## **26-702 Receptacles in Residential Occupancies (see Appendices B and G)**

## **Section 28**

**Figure 26-700(13)**  
**Receptacle Requiring GFCI Protection**

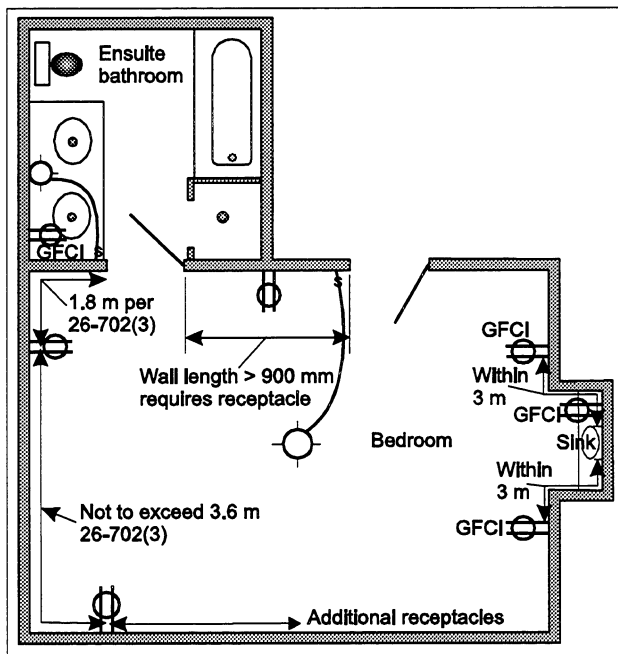
Subrule (13) requires that a receptacle that is located within 3 m of a washbasin, bathtub, or shower stall be protected by a ground fault circuit interrupter. An Appendix B Note has been added to indicate that the 3 m distance does not apply to receptacles where the measurement is taken through an opening fitted with a door. See Figure 26-700(13).

**Figure 26-706**  
**Single/Duplex Receptacle 5-20RA**

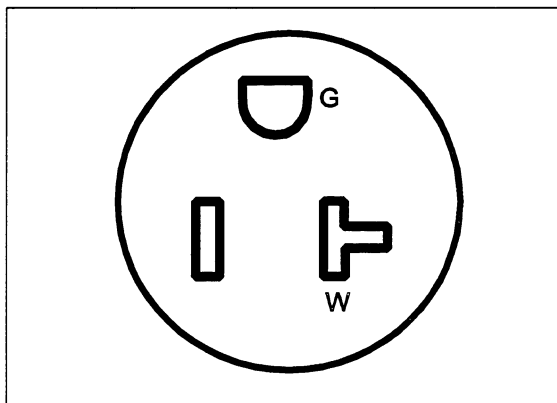
This Rule has been added to harmonize with the National Electric Code by allowing T-slot 20 A receptacles on a 120 V circuit as an alternative to the

multi-wire split receptacle above the counters in the kitchen.
